**NUMBER:** 25-001-03

Duty Cycle Purge Solenoid Causes A Ticking-Like Sound From Engine Compartment

2002 - 2004 (WJ) Grand Cherokee (Domestic Markets Only)

**Fig. 1 DCP SOLENOID & ISOLATION BRACKET**

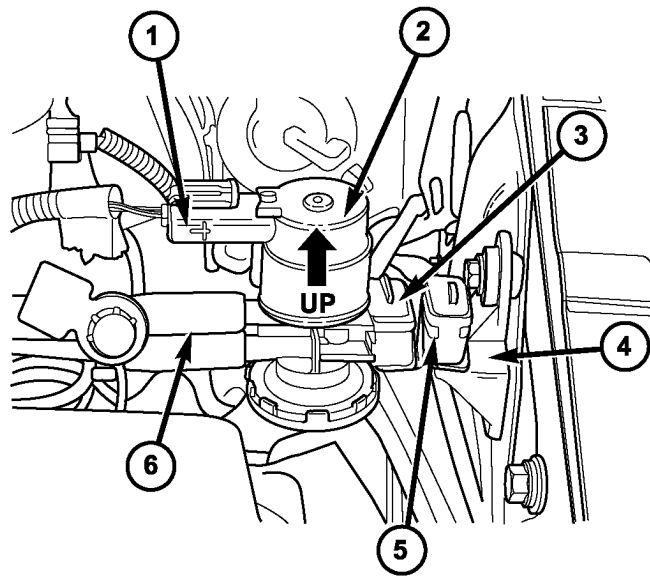
The customer while sitting in the passenger compartment may notice a ticking-like sound when the engine is idling. The sound may be more noticeable in colder ambient temperatures. Mechanical contact between the DCP solenoid and the body of the vehicle may be the cause of the ticking-like sound.

**NOTE: THE DCP SOLENOID HAS A CORRECT MOUNTING ORIENTATION. THE BODY OF THE DCP SOLENOID IS MARKED WITH THE WORDS "UP" AND "BOTTOM". THE ELECTRICAL SECTION OF THE SOLENOID MUST BE ON TOP WHILE THE DIAPHRAGM PORTION OF THE SOLENOID MUST FACE DOWN.**

2. Remove the DCP solenoid from its plastic body mounting bracket by grasping the DCP solenoid and lifting upward.
3. Note how the rubber bushing is installed to the DCP solenoid before removing the bushing from the solenoid. The original bushing has a wide slot through

the middle of the bushing. Remove the original bushing and install the new bushing with the narrow slot, p/n 53030987.

4. Install the new isolation U-bracket to the plastic body mounting bracket.
5. Install the DCP solenoid (with the new narrow slot bushing) to the isolation U-bracket. Make sure that the DCP solenoid is correctly oriented. (Fig. 1)
6. Install the evaporative vapor lines and the electrical connector to the DCP solenoid.
